Charlestown Place SHD

Quality Audit - Stage 1

Puddenhill Property Limited

February 2021

Figure 2-1 – Northern approach to the Charlestown Place crossing

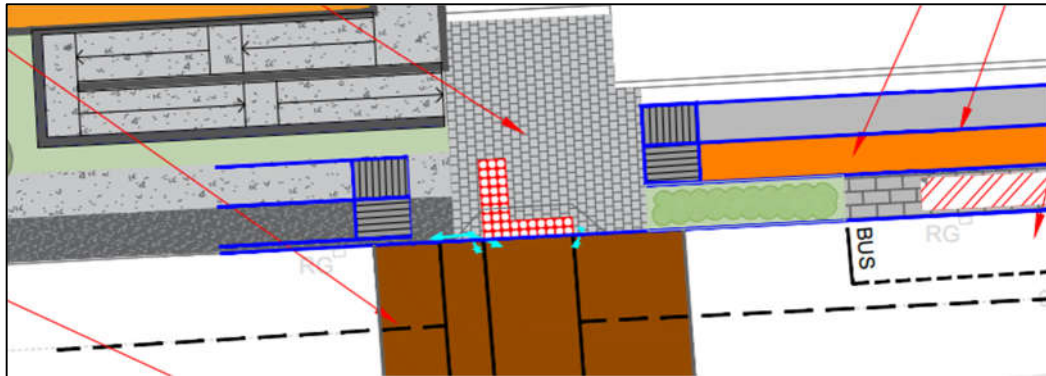
Location: At the Northern approach to the Charlestown Place crossing

The alignment of the pedestrian and cyclist facilities either side of the shared crossing could result in collisions as users move from their desire lines to continue on their respective paths. This could lead to an increase in pedestrian and cyclist collisions resulting in injuries.

The Design Team should consider realigning the cycle track and footpath facilities on the east approach facilitate desire lines.

2.1	Y	N	To address this item, the layout has been amended to introduce the interface between the shared area and cycle track / footpath earlier on both approaches so as to allow pedestrians and cyclist more space and time to mix with one another in advance of the crossing. This will facilitate users to be familiar with one another's movement and desire lines and reduce potential conflict.	Y

Figure 2-3 – Bus Stop on the Westbound Carriageway of Charlestown Place

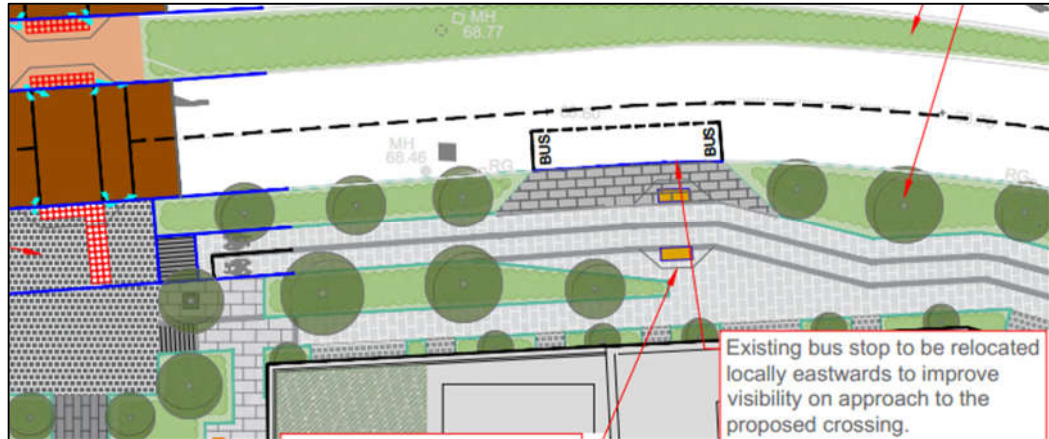
Location: At the Bus Stop on the Westbound Carriageway of Charlestown Place
Passengers boarding/alighting at the bus stop may, if coming from our going to the crossing, chose to follow the direct desire line which would take them through the cycle track. This could lead to an increase pedestrian and cyclist collisions resulting in injuries.

The Design Team should consider rearranging the cycle and footpath facilities so as to encourage pedestrians away from utilising the cycle track.

2.3	Y	N	To address this item, the design will be amended to place the main footpath directly adjacent the cycle track.	Y
2.4	Y	N	Similar to the measure put forward in 2.1, the layout will be amended to introduce the interface between the shared area and cycle track / footpath earlier on both approaches so	Y

Figure 2-4 – Southern approach to the Charlestown Place crossing

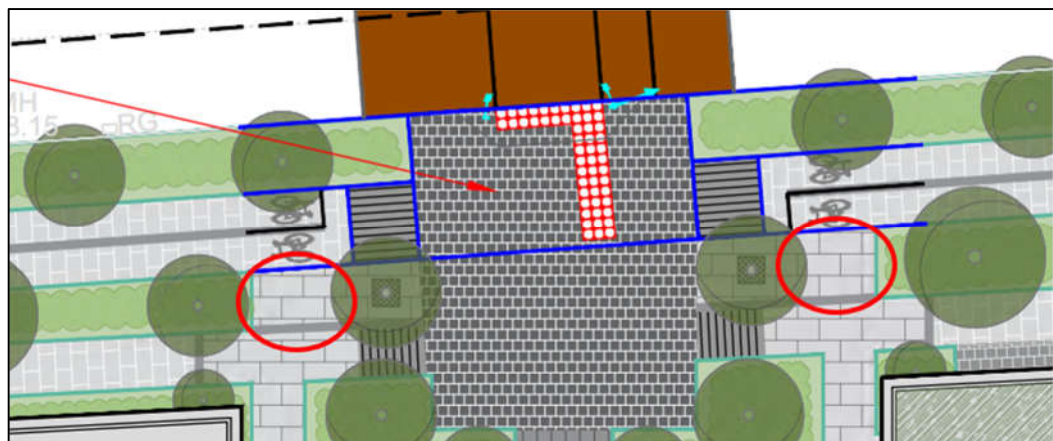
Location: At the Southern approach to the Charlestown Place crossing
Breaks in the line of vegetation as pictured in Figure 2-4 below may lead pedestrians into the path of cyclists utilising the cycle track. This could lead to an increase pedestrian and cyclist collisions resulting in injuries.

The Design Team should consider planting at this location to restrict pedestrian movement in the cycle track and encourage a desired approach to the crossing.

as to allow pedestrians and cyclist more space and time to mix with one another in advance of the crossing, and associated urban space. This will facilitate users to be familiar with one another's movement and desire lines and reduce potential conflict.	
2.5	Y	Y	The crossing location and associated tactile paving will be relocated southwards to line up with the desire line between the pedestrian and cycle tracks on either side of the street.	Y
2.6	Y	Y	The design will specify appropriate low ground cover (basic ivy) planting which typically does not grow above 300-400mm adjacent the junction radii. The proposed trees, whose canopies will be specified to lie approximately 2m above ground level, lie outside of the required visibility splays and this will be demonstrated on the engineering drawings.	Y

Figure 2-5 – Northern approach to the Charlestown Place crossing

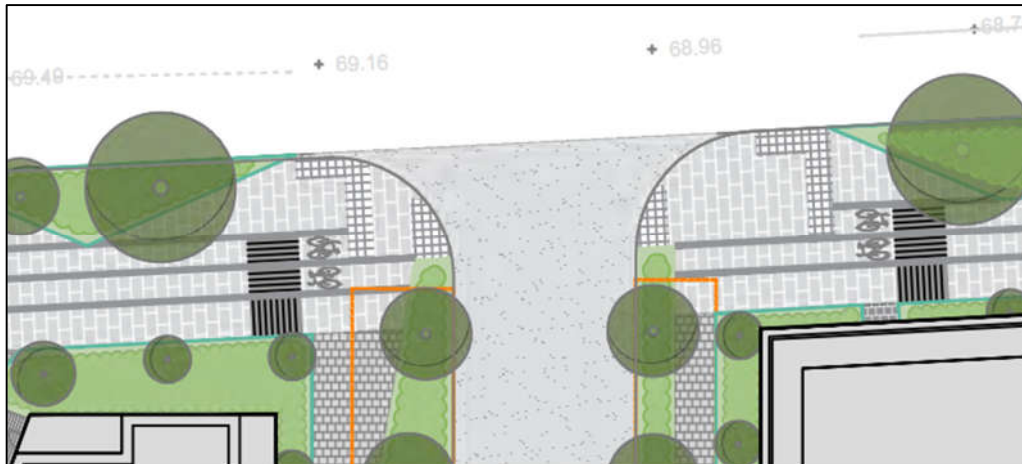
Location: At the Southern arm of the Charlestown Place junction

The crossing on the southern arm of the Charlestown Place junction is off the main desire line. Cyclists and pedestrians looking to cross at this location may choose to carry out a more direct crossing which could result in slips, trips and falls into a live trafficked carriageway resulting in injuries. In addition, the crossing position creates a conflict between pedestrians and cyclists as pedestrians may cross into the cycle path for a direct route to the crossing resulting in conflicts with cyclists.

The Design Team should consider setting back the crossing in line with the crossing desire line.

Figure 2-6 – Example of Visibility Obstruction at Junctions throughout the proposal

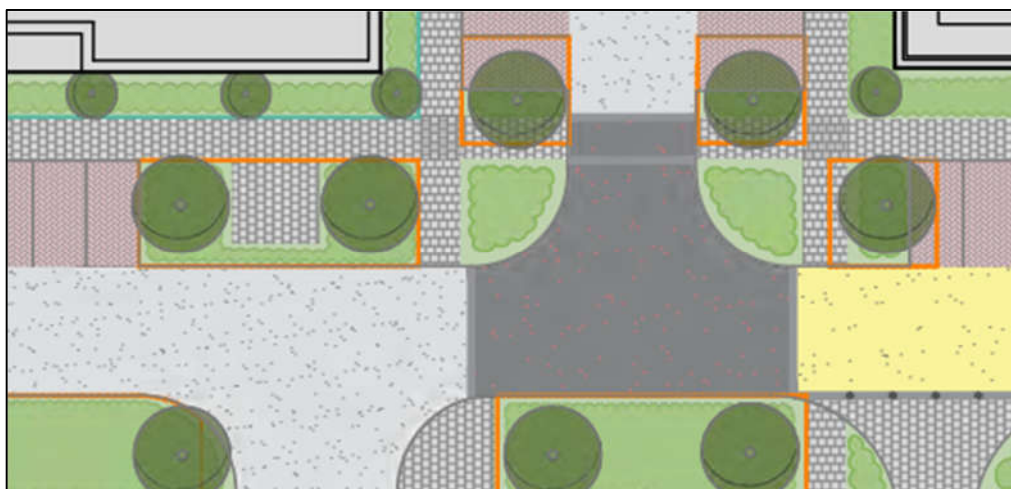
Location: At Junctions throughout the proposal

The proposal describes the location of tree planting in close vicinity to several of the junctions throughout the scheme. Vehicles manoeuvring the junction or utilising the car parking spaces may have their views obstructed by the trees. This could result in side impact or rear end type collisions which may cause material damage, serious or fatal injuries.

The Design Team should ensure visibility splays are maintained.
